STADIUM AREA-ELECTRICAL
SCALE: 1/4" = 1'-0"

CHANGE ORDER ITEMS

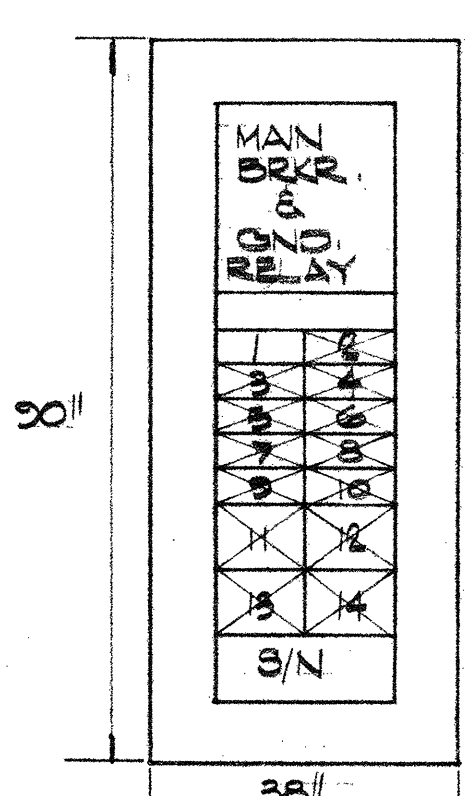
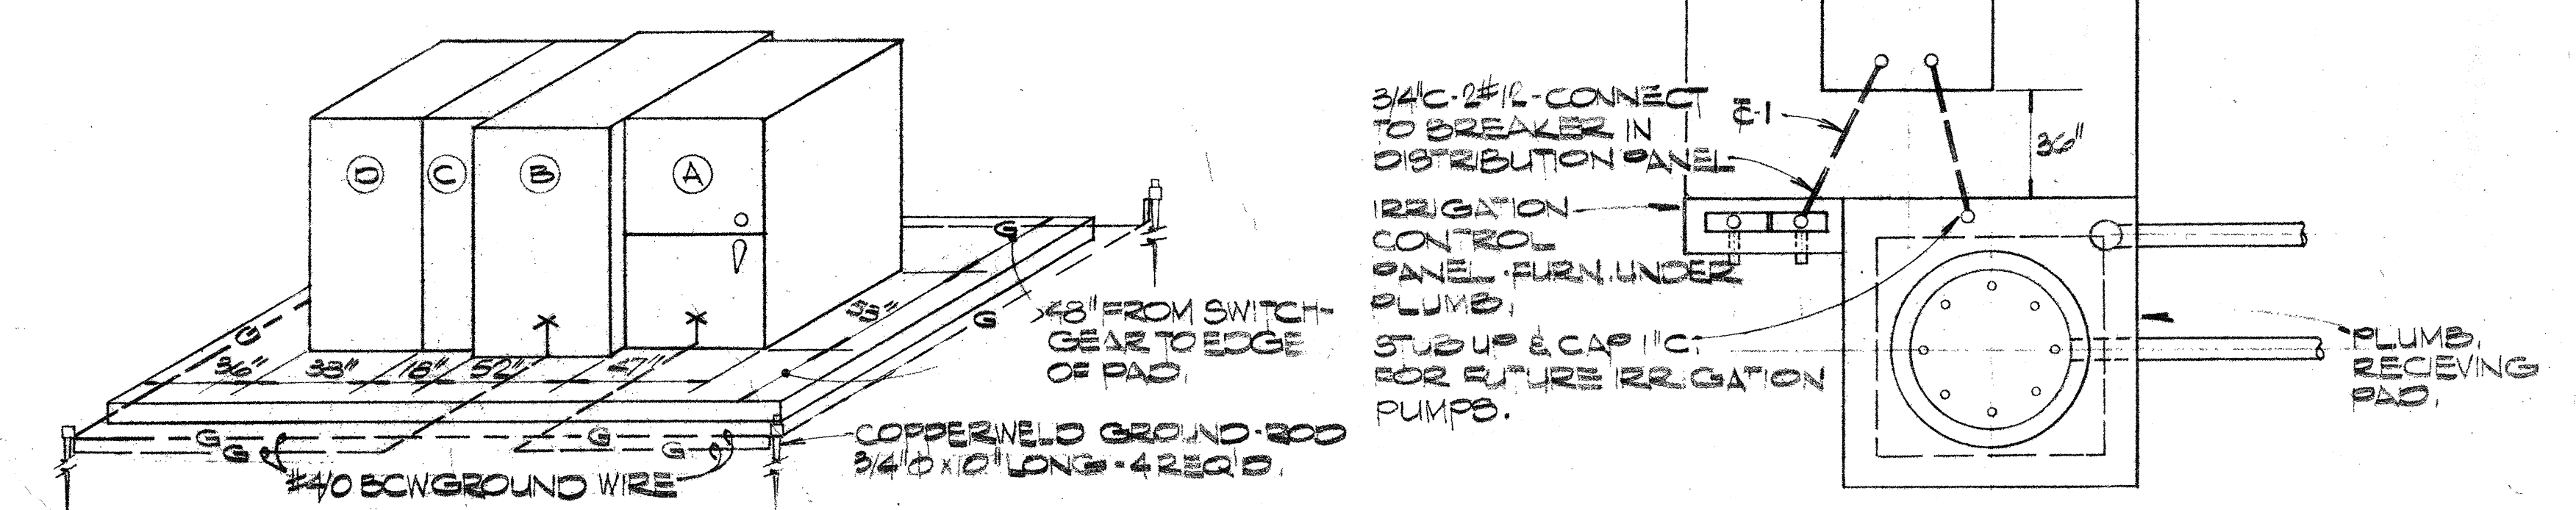
REV#	DESCRIPTION	BY	DATE
Δ	ADDED PULL BOXES @ TRACK	E.N.	8/26/70
